11 MAY, 1988

BULLETIN.003

SYNCHRO-PULSE CDT 350: CP34 CP34-29 FUNCTION PCB

TITLE
CP34-29/01 COMPONENT OVERLAY.
FUNCTION BOARD.

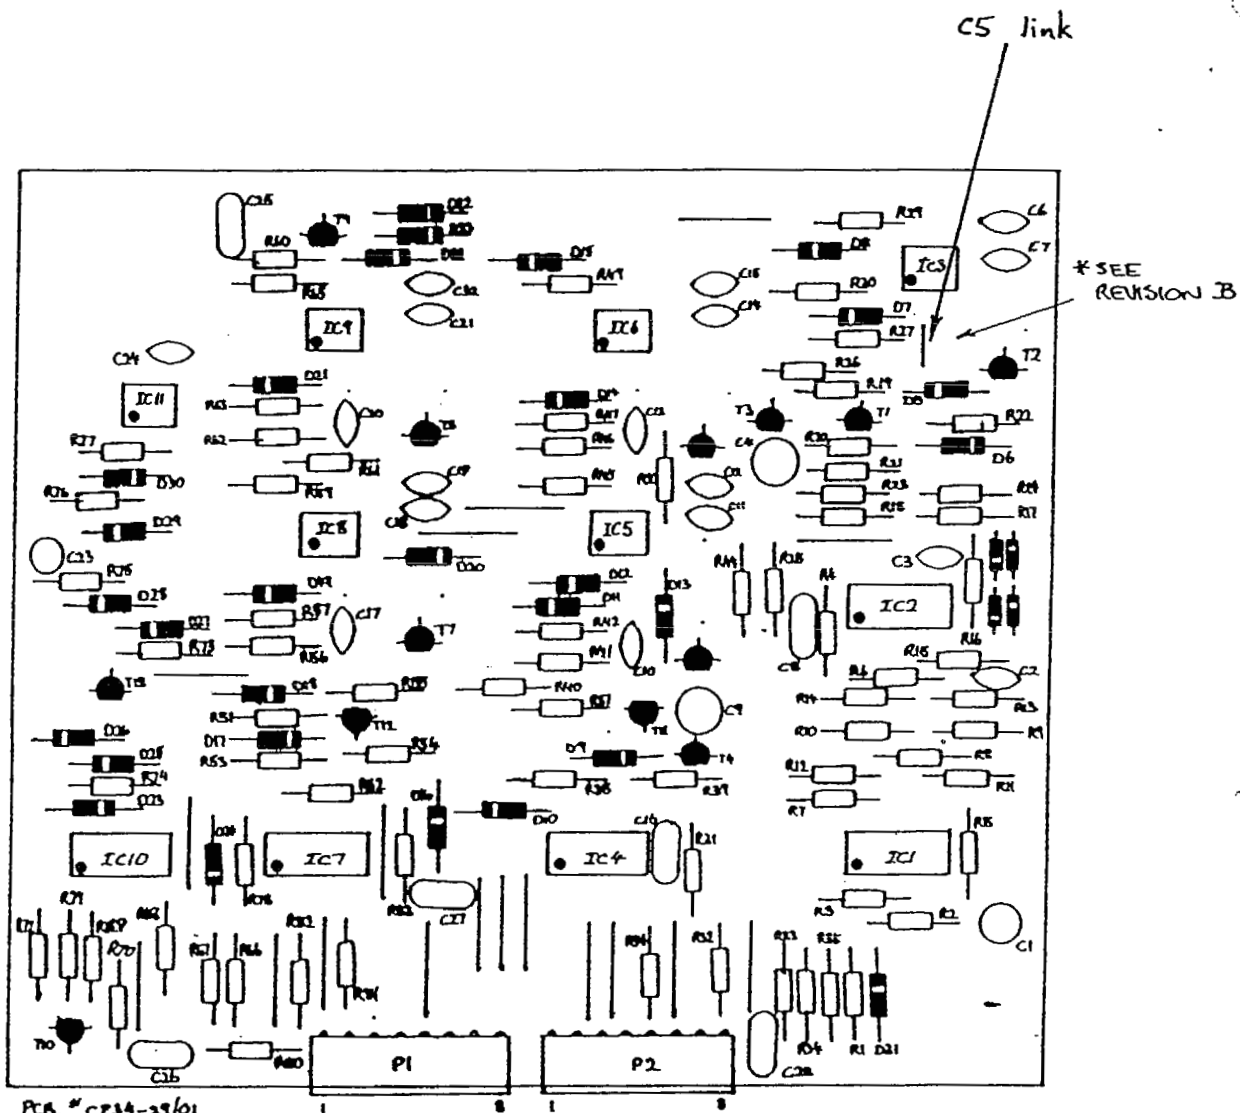
Capacitor C5 (Greencap) is to be removed and replaced by a link.

This is to overcome a latch-up fault, which is when there is insufficient power to melt the welding wire properly, causing the wire to coil up onto the workpiece like "cold spaghetti".

Refer to attached component overlay for position of C5.

F			
E			
D			
C			
B	11-5-88	GC	CS REPLACED BY LINK RE LATCH-UP FAULT
A	22/1/85		RESISTOR NUMBERS CORRECTED
ISSUE	DATE	CHK'D.	REVISION
